NOTES: This Form is used in connection with an application for the Secretary of State for Energy and Climate Change's consent under section 37 of the Electricity Act 1989 to install and keep installed above ground an electric line of a nominal voltage of less than 132 kilovolts. The form should be sent in quadruplicate to each County / District / Borough Council in whose are the proposed development would be situated.

Applicant's reference: **DI73988**

Planning Reference No. NYM/2019/0154/EN/OHL

Studdale to Low Waupley Map

Public Right of Way Map

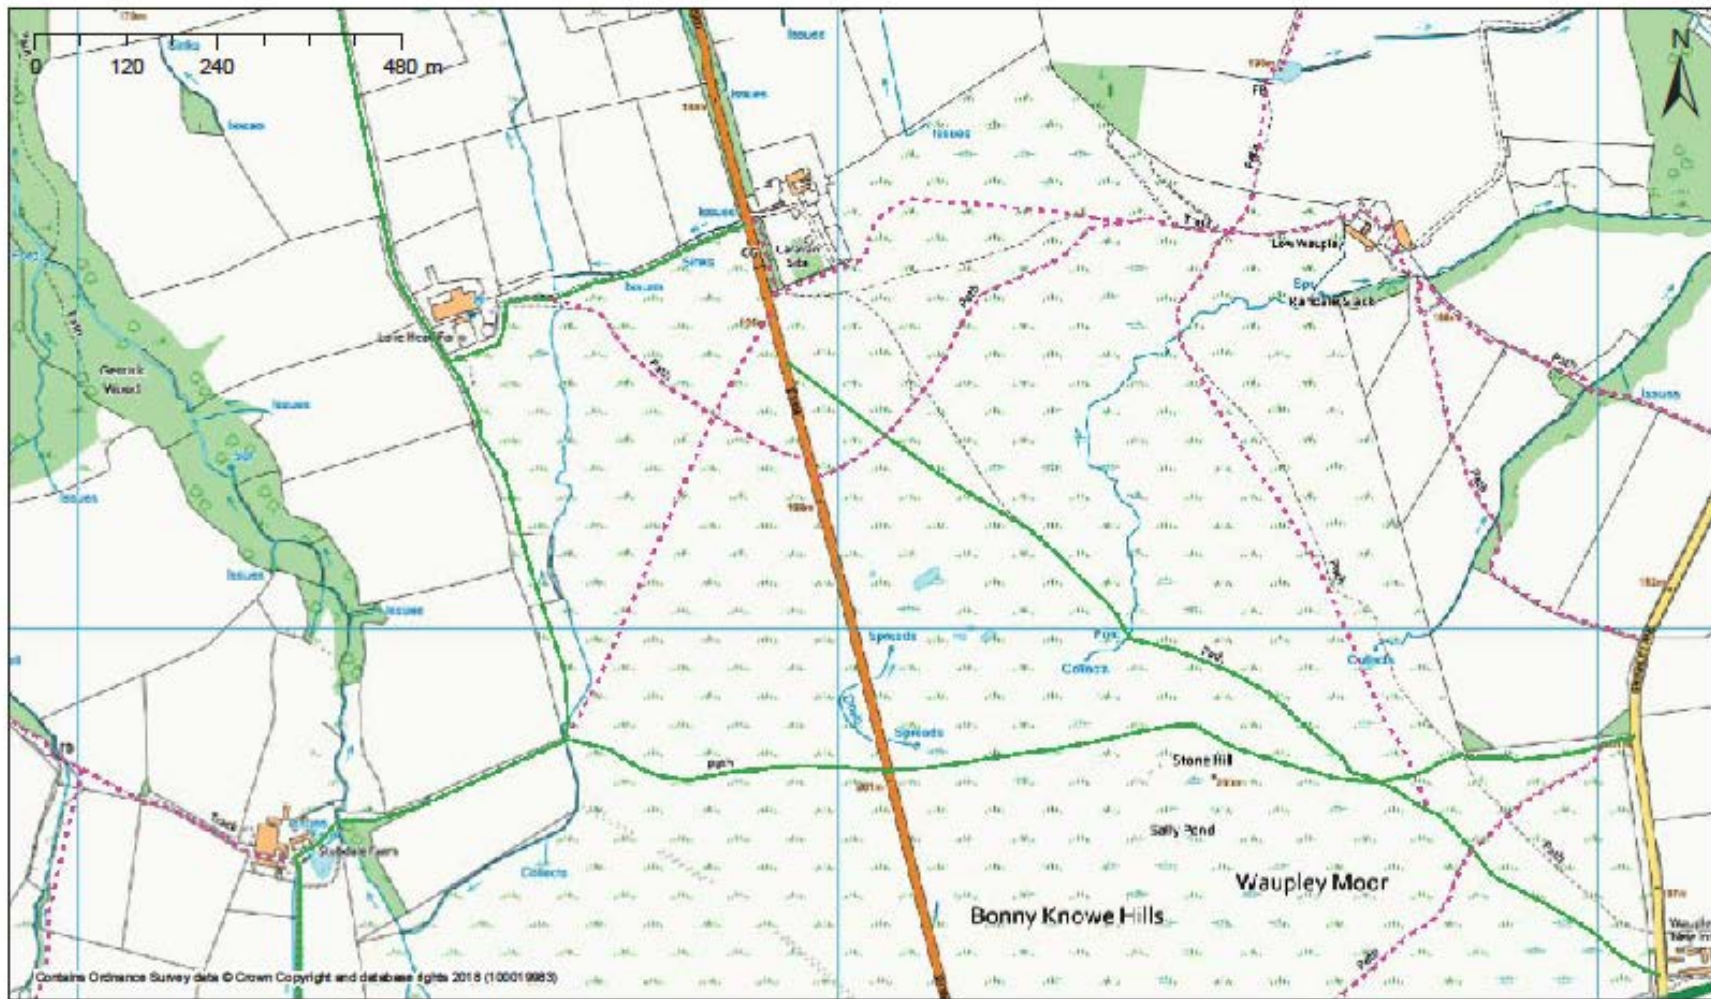
Senior Strategic Transport Officer (Redcar & Cleveland) - The route of the electricity line crosses several public rights of way as shown on the attached map. There must be no unauthorised interference with the use of these PROWs during the course of the works. We must be informed in advance of any works that will affect the use of any PROW so that appropriate steps can be put in place to organise temporary diversion routes.

Location Plan of LiDAR and HER near posts 22 and 23

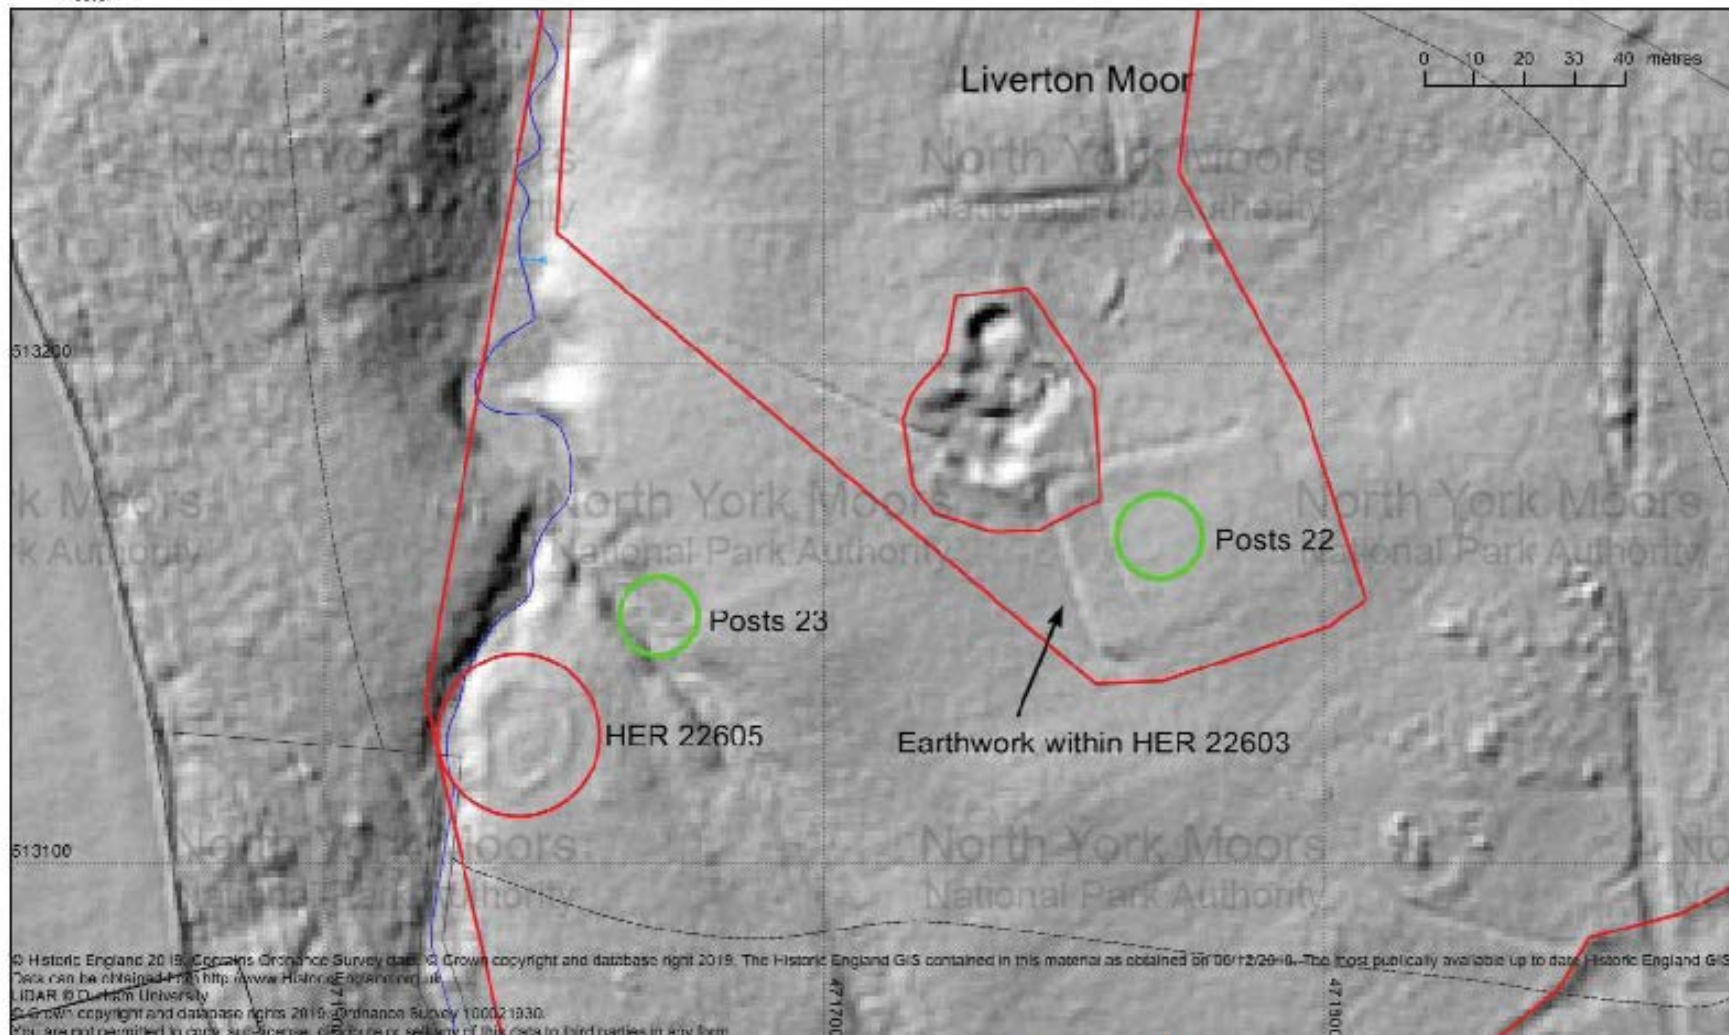
Pole 22: Lies within HER 22603, and in the centre of a very clear subrectangular earthwork enclosure. Obvious on LiDAR. Been interpreted as prehistoric settlement feature. Very similar to a nearby Scheduled Monument south of Gerrick. Could extreme care be taken when accessing the site. Access from the east please, as less visible earthworks will be affected. The siting of the new pole will require a watching brief by an archaeologist due to the high potential of the site, with appropriate WSI/report.

Pole 23: Existing/replacement pole lie immediately to the east of HER 22605, a prehistoric ring bank with possible building platform in the centre. Obvious on LiDAR. Please access by driving around this HER record, do not drive on or over it.
